# Supplement to comment about CheckGrantSize(length)

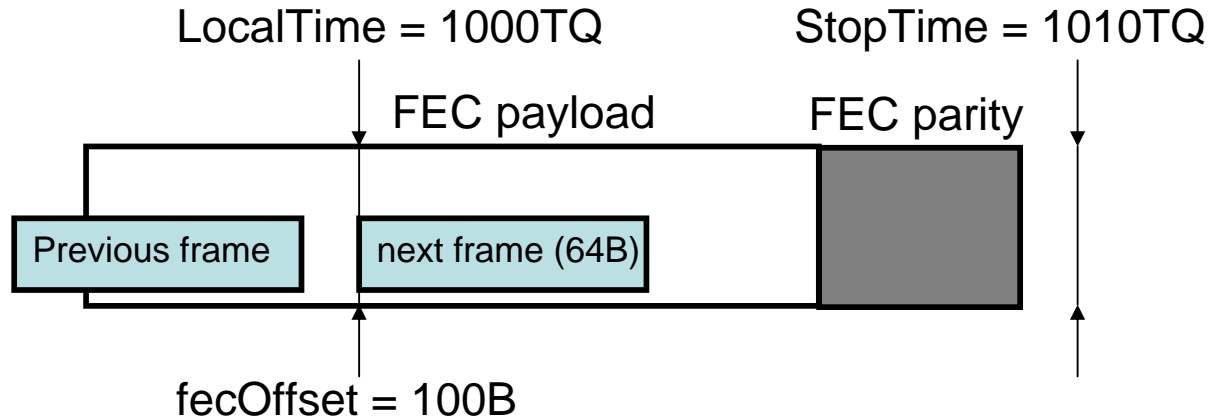
The issue : The current equation of CheckGrantSize(length) may cause wrong process in case of the condition as below.

## Current Calculation:

$\text{CheckGrantSize}(\text{length}) = \text{ceiling} \left( \frac{(\text{fecOffset} + \text{length})}{\text{FEC\_PAYLOAD\_SIZE}} \right) * \text{FEC\_CODEWORD\_SIZE}$   
 $\text{ceiling} \left( \frac{100 + (64 + 20)}{216} \right) * 248 = 248$   
->  $\text{NextTime} = 248 / 20 = 12$ ,  $\text{NextTime} > \text{StopTime} - \text{LocalTime}$

Frame will be deferred (wrong process).

## Correct Calculation:

$\text{CheckGrantSize}(\text{length}) = \text{ceiling} \left( \frac{(\text{fecOffset} + \text{length})}{\text{FEC\_PAYLOAD\_SIZE}} \right) * \text{FEC\_CODEWORD\_SIZE} - \text{fecOffset}$   
 $\text{ceiling} \left( \frac{100 + (64 + 20)}{216} \right) * 248 - 100 = 148$   
->  $\text{NextTime} = 148 / 20 = 7$ ,  $\text{NextTime} < \text{StopTime} - \text{LocalTime}$

Frame will be accepted (correct process).
